RSB 597
April 28, 2023

NHTSA #23V 138
TC #2023-110

RECALL SERVICE BULLETIN

GLOBAL ENTRY DOOR LATCH INSPECTION/ REPLACEMENT INSTRUCTIONS *MOTORIZED UNITS ONLY

Determine Correct Latch Assembly Part

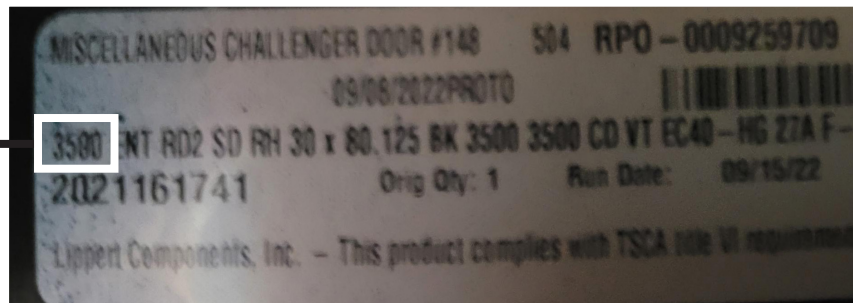
The replacement latch assembly part is determined by the serial number on the door tag. Replacement inside latch assembly for the 920 Series door is PN 2023005033. Replacement inside latch assembly for the 3500 Series door is PN 2022010407.

Fig. 5

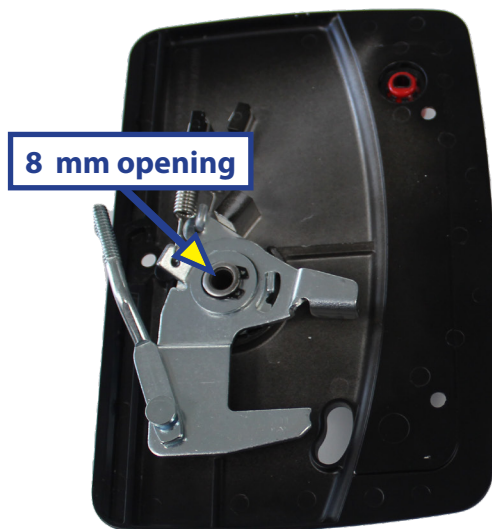
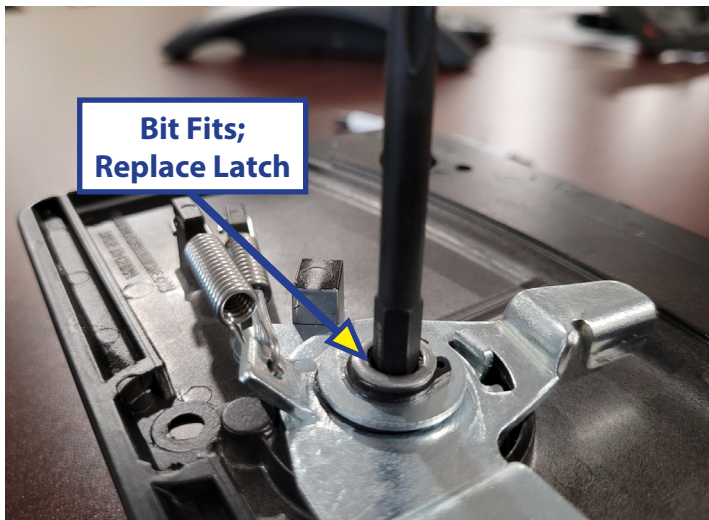
- Using a 1/4" screwgun bit, try to insert the bit into the spun rivet of the inside latch assembly (Fig. 5).
- If bit fits into rivet opening there are two options:
 - Replace the complete latch assembly, including both inside and outside latch assemblies.
 - Replace just the inside latch assembly to be combined with current outside latch assembly.
- If the bit does not fit, no action is required. Proceed to latch reassembly instructions.

New Inside Latch Assembly Needed

Replacement Not Needed
